UNITED STATES PATENT AND TRADEMARK OFFICE

APPLICATION NO.	FILING DATE	FIRST NAMED INVENTOR	ATTORNEY DOCKET NO.	CONFIRMATION NO.
10/520,961	10/25/2005	Olivier Carli	38918	4903
39313	7590	08/07/2006	EXAMINER	
CARL M. NAPOLITANO, PH.D. ALLEN, DYER, DOPPELT, MILBRATH & GILCHRIST, P.A. 255 SOUTH ORANGE AVE., SUITE 1401 P.O. BOX 3791 ORLANDO, FL 32802-3791			WOODALL, NICHOLAS W	
			ART UNIT	PAPER NUMBER
			3733

Office Action Summary	Application No.	Applicant(s)	
	10/520,961	CARLI, OLIVIER	
	Examiner Nicholas Woodall	Art Unit 3733

DETAILED ACTION

Figure 1

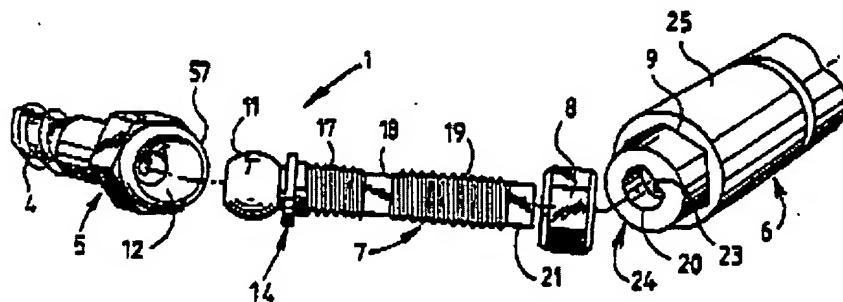
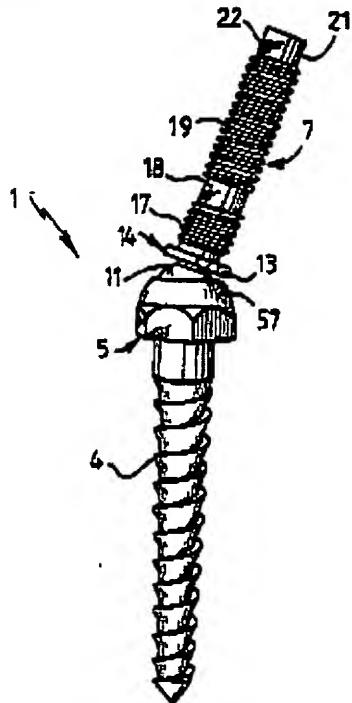
6. Claims 1, 3-6, and 9 are rejected under 35 U.S.C. 102(b) as being anticipated by Taylor (U.S. 6,267,765).

Regarding claim 1, Taylor discloses a device comprising a bone anchor element (4), spherical articulation between the anchoring element (4) and a threaded shaft (7), and a rotational linkage means (11 and 12) as shown in Figures 1 and 2 below. The bone anchor element is provided with a head (5). A means for spherical articulation is provided between the head (5) of the anchoring element and a threaded shaft (7). A rotational linkage means (11 and 12) is also provided between the bone anchor element

(4) and a threaded shaft (7). Regarding claim 3, Taylor discloses a device wherein the rotational linkage includes a female geometry (12) and complementary male geometry (11). Regarding claim 4, Taylor discloses a device wherein one of the geometrical forms is located on the bone anchor element (4) and the other is located on the threaded shaft (7). Regarding claim 5, wherein one of the geometrical shapes is provided on the end face of the bone anchor element (4). The geometrical shape (12) extends within an open housing (57) in the head of the bone anchor (4) for receiving the end (11) of the threaded shaft (7). The ends (11 and 12) of the bone anchor (4) and the threaded shaft (7) form a ball and socket joint to form the spherical articulation between the two elements. Regarding claim 6, Taylor discloses a device wherein the transverse face (bottom surface of element 14) of the ball and socket joint and the end face (upper face of element 57) of the bone anchor (4) are separated by a distance to allow for multiple orientations of the threaded shaft (7). Regarding claim 9, Taylor discloses a device wherein the receiving head (5) forms a grip nut for a screwing tool.

Figure 3

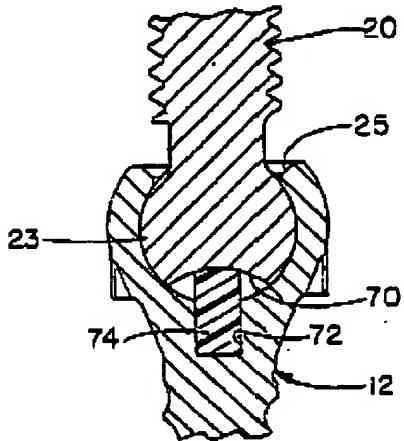
7. Claims 1-8 are rejected under 35 U.S.C. 102(b) as being anticipated by Altarac (U.S. Publication 2004/0006342).

Regarding claim 1, Altarac discloses a device that comprises a bone anchor (12), spherical articulation between the bone anchor (12) and a threaded shaft (20), and a rotational linkage (70 and 72) means between the bone anchor (12) and the threaded shaft (20) as shown in Figure 3 below. The bone anchor (12) is provided with a head (18). A means for spherical articulation is provided between the head (18) of the anchor (12) and the threaded shaft (20). A rotational linkage means (70 and 72) is also provided between the head (18) of the anchor (12) and the threaded shaft (20).

Regarding claim 2, Altarac discloses a device wherein the rotational linkage means (70 and 72) are located outside of the spherical articulation means (23 and 24). Regarding

claim 3, Altarac discloses a device wherein the rotational linkage means comprises a female geometry (70) and a complementary male geometry (72). Regarding claim 4, Altarac discloses a device wherein one of the geometrical forms is located on the bone anchor (12) and the other geometrical form is located on the threaded shaft (20). Regarding claim 5, Altarac discloses a device wherein one of the geometrical forms (74) is provided on an end face of the bone anchor (12). The geometrical form (74) extends within an open housing (24) provided in the head (18) of the anchor (12) and receives the end (23) of the threaded shaft (20) to form a ball and socket joint for the spherical articulation. The other geometrical form (70) is located on a transverse face of the ball and socket joint (23). Regarding claim 6, Altarac discloses a device wherein a transverse surface (70) of the ball and joint socket is located a distance from a end face (upper face of element 25) of the bone anchor (12) to allow multiple orientations of the threaded shaft (20). Regarding claim 7, Altarac discloses a device wherein at least one of the transverse faces of the ball and socket joint (23 and 24) or the end faces of the bone anchor (12) have a convex shape. Regarding claim 8, Altarac discloses a device wherein the male geometrical form (74) is on the bone anchor (12) and the female geometrical form (70) is located on the ball and socket joint (23).
